Model: AP-C3	Date: 15-Feb-12	No.: RD144001
--------------	-----------------	---------------

Subject: Firmware Release Note: ADF_MANASLU_B		Prepared by: H. Tamaki	
From: 1st Tech Service Sect., MFP/Printer Tech Service Dept.			
Classification:	<input type="checkbox"/> Troubleshooting	<input type="checkbox"/> Part information	<input type="checkbox"/> Action required
	<input type="checkbox"/> Mechanical	<input type="checkbox"/> Electrical	<input type="checkbox"/> Service manual revision
	<input type="checkbox"/> Paper path	<input type="checkbox"/> Transmit/receive	<input type="checkbox"/> Retrofit information
	<input type="checkbox"/> Product Safety	<input checked="" type="checkbox"/> Other (Firmware)	<input checked="" type="checkbox"/> Tier 2

This RTB has been issued to announce the firmware release information for the **ADF_MANASLU_B**.

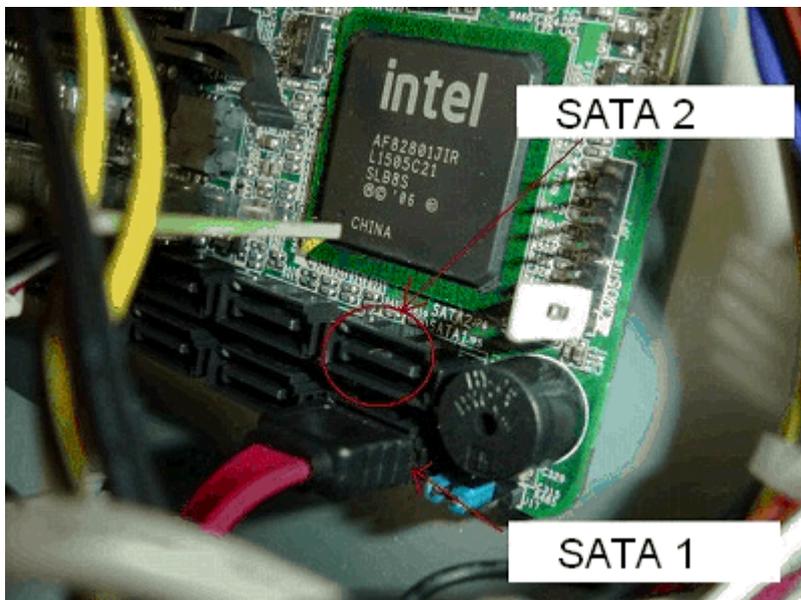
The HDD cable is mistakenly connected to the SATA 2 port, instead of the correct SATA 1 port.

3. Remove the HDD cable connector from SATA 2, and then reconnect it to **SATA 1**.

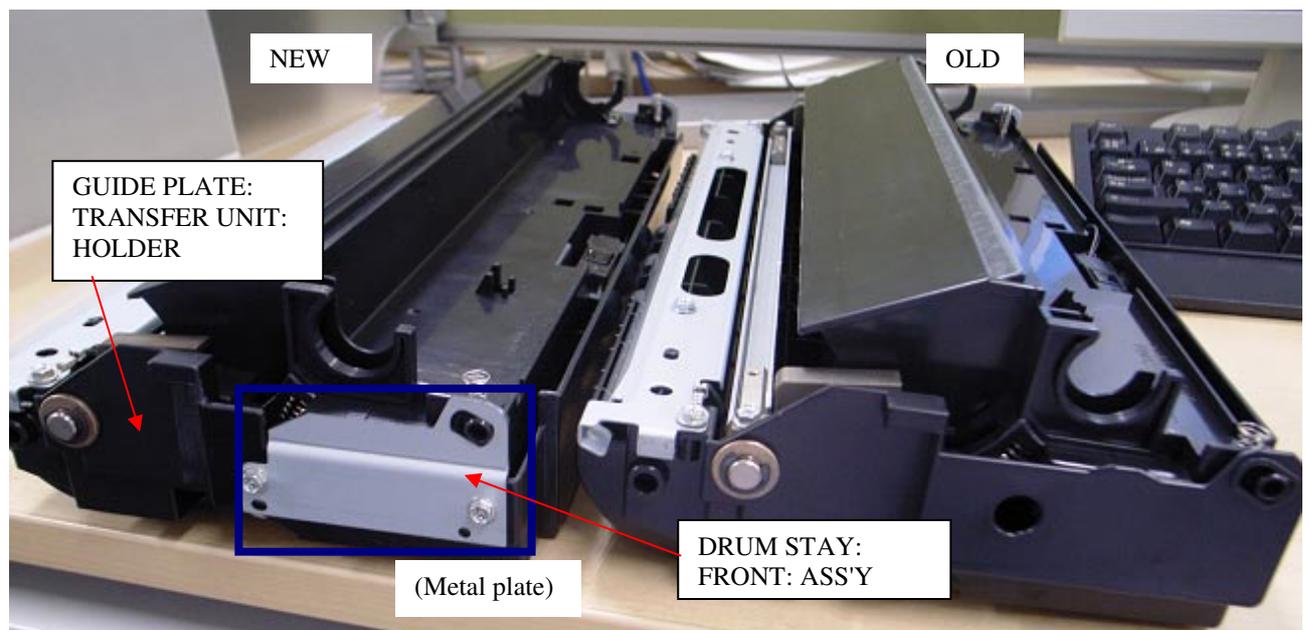
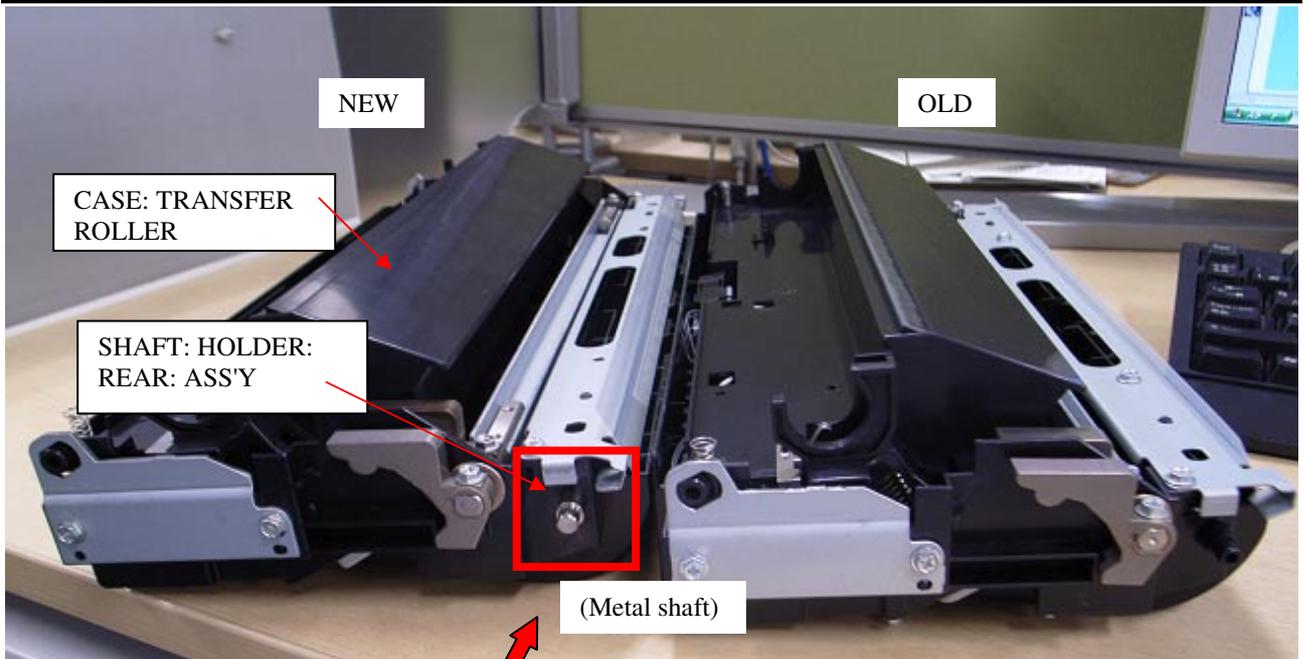
Reason: To further increase the load-bearing strength of the parts.

Important: Interchangeability is **X/O as a set** (all six parts together).

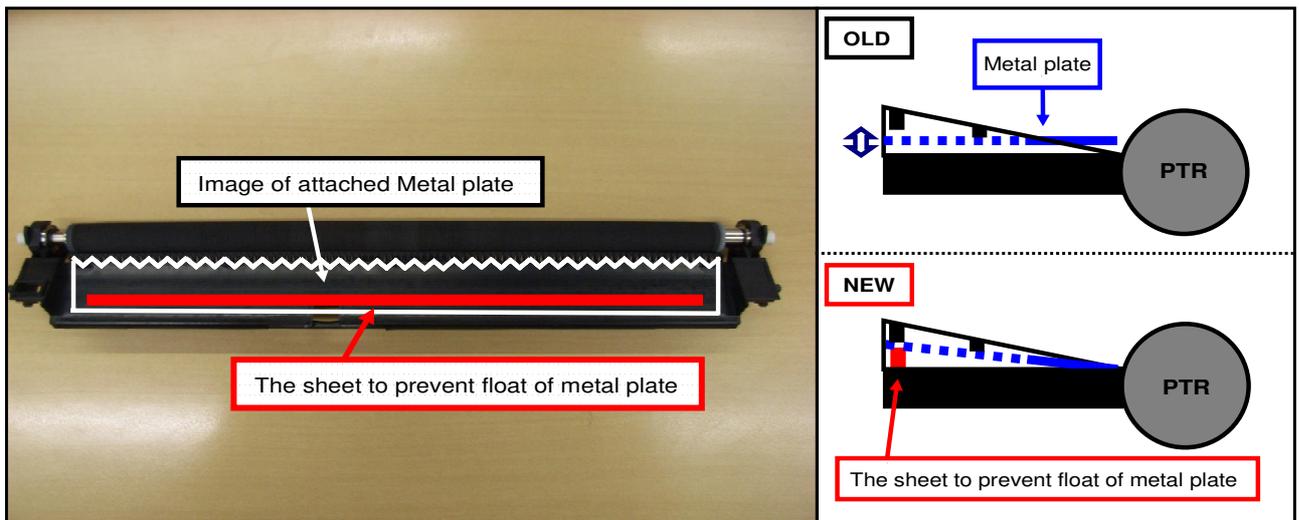
Old part number	New part number	Description	Q'ty	Int
D1446204	D1446205	TRANSFER/SEPARATION UNIT:C3:ASS'Y	1	X/O

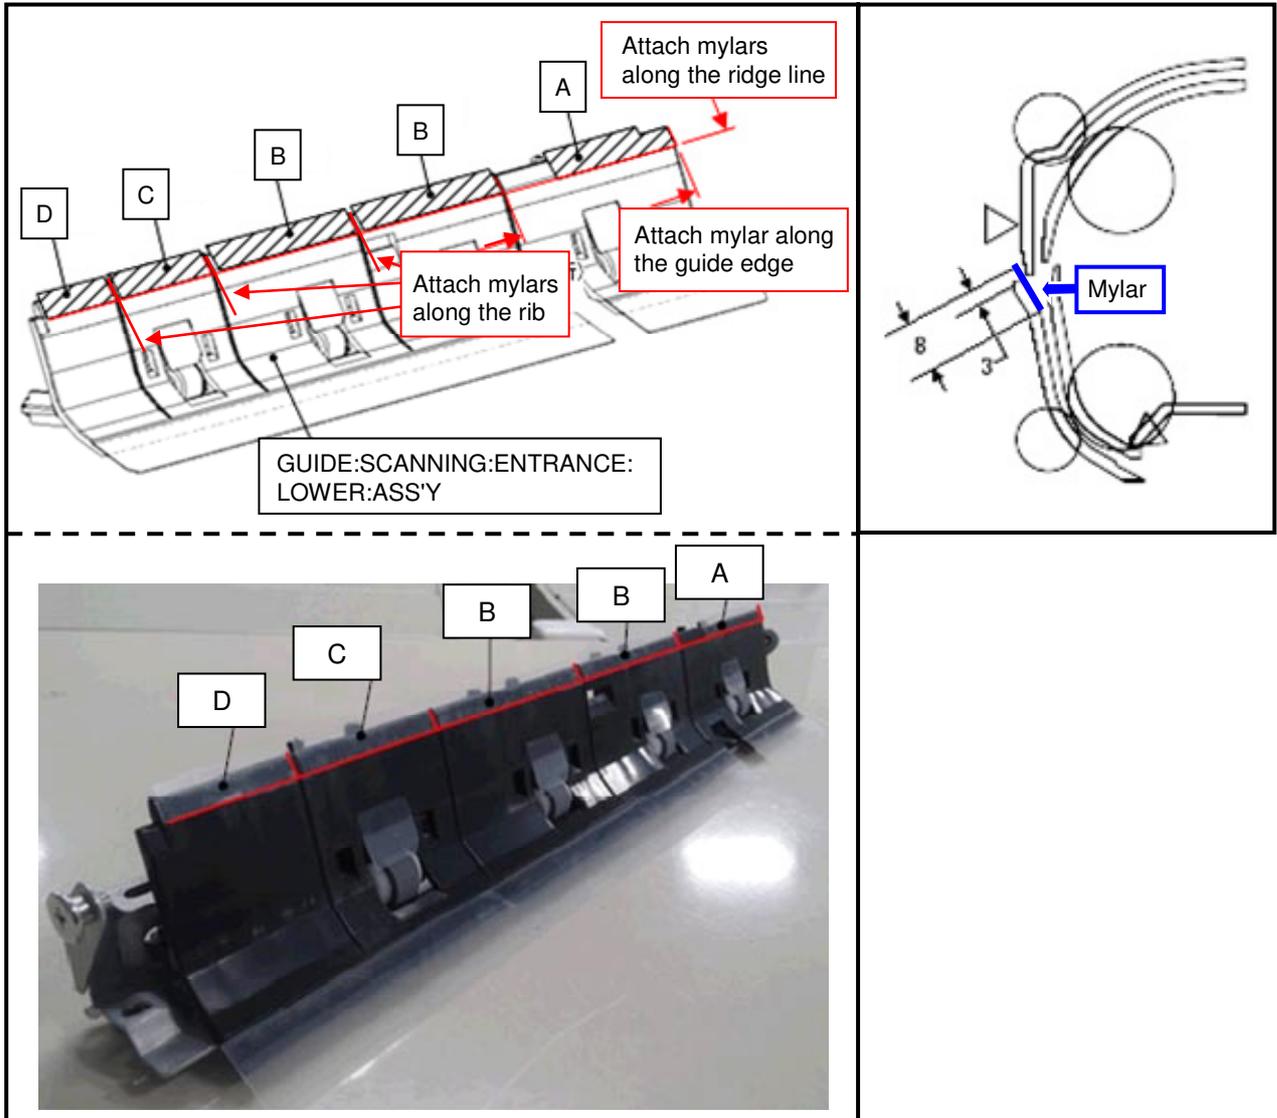
The lower paper feed guide is slightly warped, which can damage the original if the original is curled.

The original may impact the “GUIDE:SCANNING:ENTRANCE:LOWER:ASS'Y” after exiting the “GUIDE:PAPER FEED:LOWER”.

1. Attach the five Mylars to the "GUIDE:SCANNING:ENTRANCE:LOWER:ASS'Y" as follows.

Location of new seal (D1441099)

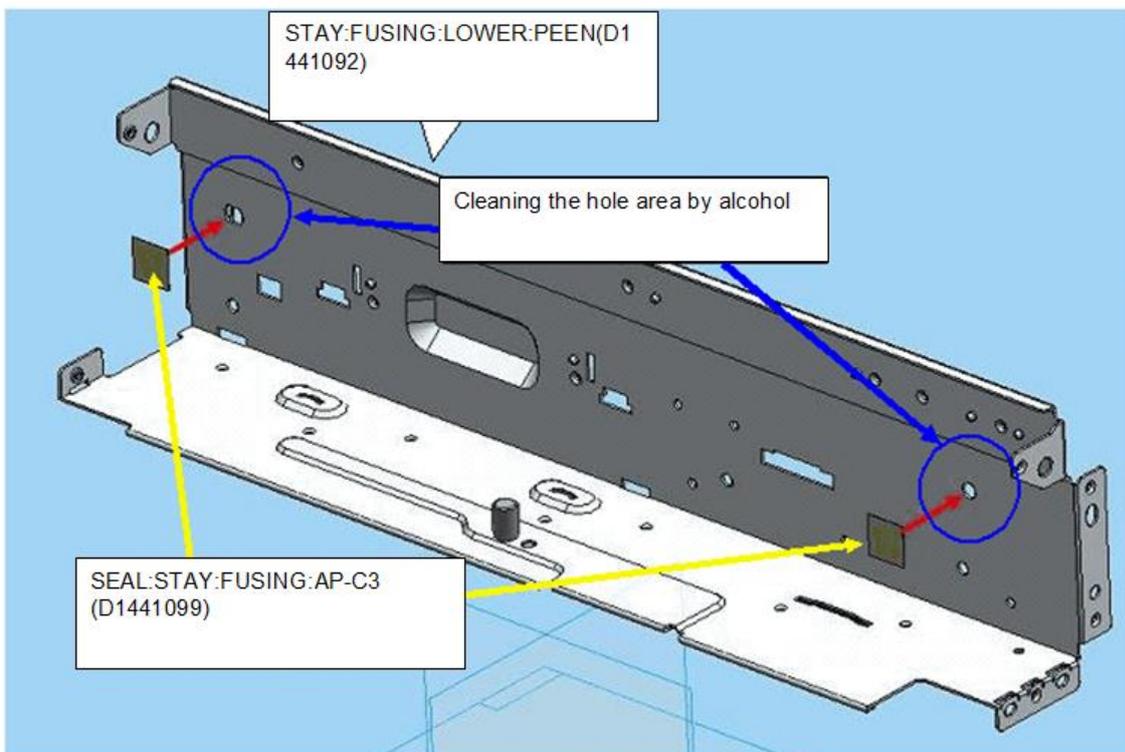
Reason: To further ensure toner scattering inside the machine does not occur.

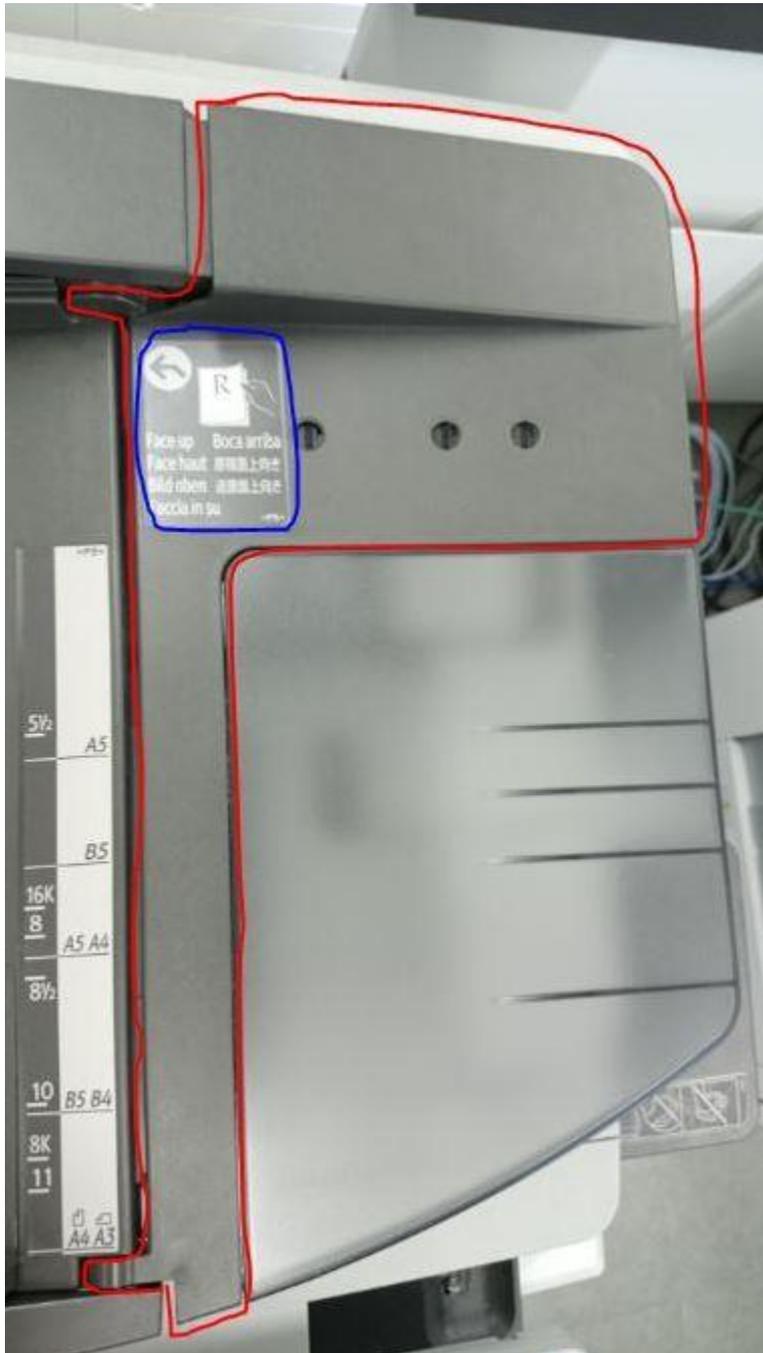
Part outlined in **red** is D6422771, and **blue** D6426031.
